WINNETKA PARK DISTRICT SPECIAL BOARD MEETING: LAKEFRONT WORKSHOP Hubbard Woods School Auditorium, 1110 Chatfield Road THURSDAY, AUGUST 25, 2022 | 6:00 p.m.*

ELDER/CENTENNIAL BEACH FEASIBILITY STUDY

The following plan concept was submitted by Chuck Dowding.

Elder Now Plan to produce swimmable beach without foreclosing options Observations

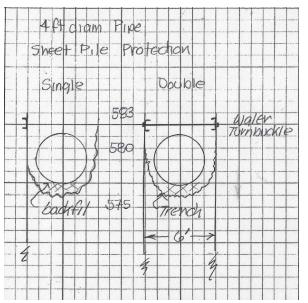
I As a first step avoid use of stone breakwater by relying on the bluff stabilization devices now in place which withstood the last high lake level. With lake at its average level (580) there is less urgency than at Lloyd.

II Some/many feel that Lloyd has too much sand and the elevation 591 or even the proposed Elder 589, 300 foot long breakwater produce a 11 or 9 ft wall at the water's edge when at the average (and present) lake level of 580

- Leave in place sheet pile groin at boundary between Elder/261 (elevation ~ 583) at southern end of 300 feet on drawing to right
 - Preserves view south at average lake level of 580

- Allows for modest addition of sand to enlarge Elder beach if necessary
 - Can be removed at later date if necessary
- Build pollution reduction devices for Village storm sewer outfall already designed by Burke

- Revisit outfall discharge design; Why diffuser?
- Replace present design of two, 3 ft diameter storm water pipes with one 4 ft diameter pipe. This 4 footer provides 14% additional capacity compared to the 3 ft and 2.25 ft Village pipes coming to Elder.

- In surf zone, encase outfall pipe in sheet pile protection with maximum height of sheet piles equal to present groin height of 583. See drawing on right

- Beyond surf zone bury pipe in clay trench
 200 ft out as presently planned or
 350 ft to extend to deeper water for greater
 dilution and long shore drift flow

- Demolish pier housing present outfall pipe in middle of beach
- Build ramp in such a manner to take advantage of the new north sheet pile groin that encases/protects the outfall pipe.

- Now have some 400 ft beach to repurpose according to new post Lloyd use patterns
- Add beach sand if necessary
- Go swimming
- Continue negotiating with Ishbia

- Add stone breakwater if necessary

Landfills masquerading as planter pockets to enable vegetation barriers

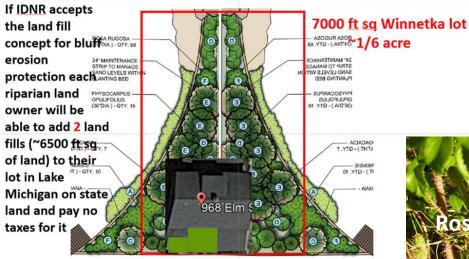
I appreciate that the Winnetka Park District is trying to increase beach access by rejuvenating Elder-Centennial parks. Unfortunately by including large landfills (mischaracterized as planter pockets), the WPD is inadvertently decreasing beach access along 64 miles of Illinois beaches for many more people for a very long time. If IDNR accepts the landfills shown below, all riparian land owners along 64 miles of Illinois Lake Michigan beach will be able to employ vegetation to deny access to public beach. Rosa Rugosa, a dense thorny rose bush shown below, will physically block access. In addition each riparian land owner will be given the ability to fill in approximately some 6500 ft sq (\sim 1/6 acre) of Lake Michigan and probably pay no taxes on that new land. The illustration below compares two Centennial landfills associated with the July workshop plan with the foot print of my house.

No other bluff erosion protection structure in Illinois has vertical planter boxes on beach or fence on top of erosion protection
